Access Compliance Report

Public Rights-of-Way

(Pedestrian Signals)

Intersection ID: N/A	Main Street:	Cross Street: N/A	Location: N/A
ADA ID: 094F3FB85677	Signal Type: Two Push Buttons-APS	Overall Compliance: No	Severity Score: BTN 1:N/A BTN 2: N/A No BTN: N/A
Codes/Mitigation Info/Possible Solution		Field Measurements/Component Compliance

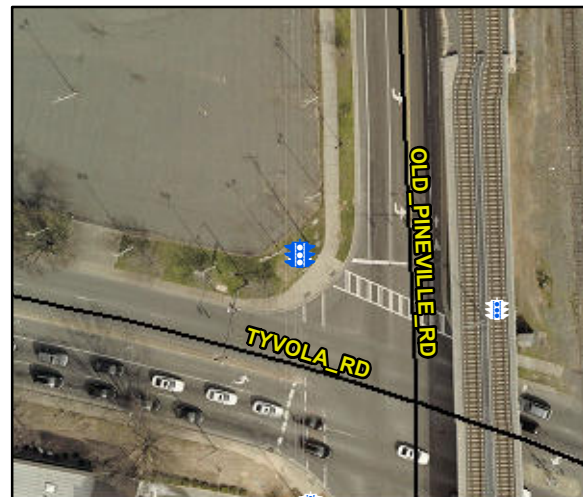
PROW/ADA: TMUTCD 4e.08, R404.2, R404.3, R406.2,

Compliance	Description	Data	Compliance	Description	Data
	Button Count	Button2	N/A	Distant to Additional Button (in)	N/A
	Additional Button Present?	No		Additional Button ID	N/A
N/A	Signal Buttons Required?	N/A	N/A	Additional Ped Posts Required	N/A
	How Many Ped Street Xings?	2		Located In An Island/Median?	No
N/A	B 1 Sign Present?	Yes	N/A	B 2 Sign Present?	Yes
Yes	B 1 Sign Purpose?	Yes	Yes	B 2 Sign Purpose?	Yes
Yes	B 1 Sign Lettering & Contrast?	Yes	Yes	B 2 Sign Lettering & Contrast?	Yes
Yes	B 1 Parallel To XWalk?	Yes	Yes	B 2 Parallel To XWalk?	Yes
Yes	B 1 PAR to Button?	Yes	Yes	B 2 PAR to Button?	Yes
Yes	B 1 PAR to XWalk?	Yes	Yes	B 2 PAR to XWalk?	Yes
Yes	B 1 Clear Floor Space?	Yes	Yes	B 2 Clear Floor Space?	Yes
N/A	B 1 FWD Approach?	Yes	N/A	B 2 FWD Approach?	No
N/A	B 1 FWD Approach Constrained?	No	N/A	B 2 FWD Approach Constrained?	No
No	B 1 FWD Approach Reach (in)	9.0	N/A	B 2 FWD Approach Reach (in)	N/A

N/A	B 1 FWD Approach Width (in)	N/A	N/A	B 2 FWD Approach Width (in)	N/A
N/A	B 1 FWD Approach Obstruction?	Yes	N/A	B 2 FWD Approach Obstruction?	Yes
N/A	B 1 FWD Approach Obstruction Dist (in)	3.0	N/A	B 2 FWD Approach ObstructionDist (in)	N/A
N/A	B 1 PARA Approach?	Yes	N/A	B 2 PARA Approach?	Yes
N/A	B 1 PARA Approach Constrained?	No	N/A	B 2 PARA Approach Constrained?	No
Yes	B 1 PARA Approach Reach (in)	6.0	Yes	B 2 PARA Approach Reach (in)	9.0
N/A	B 1 PARA Approach Width (in)	N/A	N/A	B 2 PARA Approach Width (in)	N/A
N/A	B 1 PARA Approach Obstruction?	Yes	N/A	B 2 PARA Approach Obstruction?	Yes
N/A	B 1 PARA Approach Obstruction Dist (in)	3.0	N/A	B 2 PARA Approach ObstructionDist (in)	3.0
No	B 1 Clear Floor Space Slope (%)	2.2	Yes	B 2 Clear Floor Space Slope (%)	2.0
No	B 1 Clear Floor Space XSlope (%)	2.5	No	B 2 Clear Floor Space XSlope (%)	2.2
N/A	B 1 PAR Slope (%)	1.1	N/A	B 2 PAR Slope (%)	2.4
Yes	B 1 Height (in)	35.5	Yes	B 2 Height (in)	36.5

Yes	B 1 Clear Xing Direction?	ClearlyMarked	Yes	B 2 Clear Xing Direction?	ClearlyMarked
	B 1 Crossing Direction	To S		B 2 Crossing Direction	To SE
Yes	B 1 DistanceTo XWalk (in)	0.0	No	B 2 DistanceTo XWalk (in)	N/A
No	B 1 DistanceTo Curb (in)	160.0	No	B 2 DistanceTo Curb (in)	160.0
Yes	B 1 Diameter (in)	2.0	Yes	B 2 Diameter (in)	2.0

Possible Solutions: Replace Signal Push Button With APS Button on New Post. Remove & Relocate Sign.
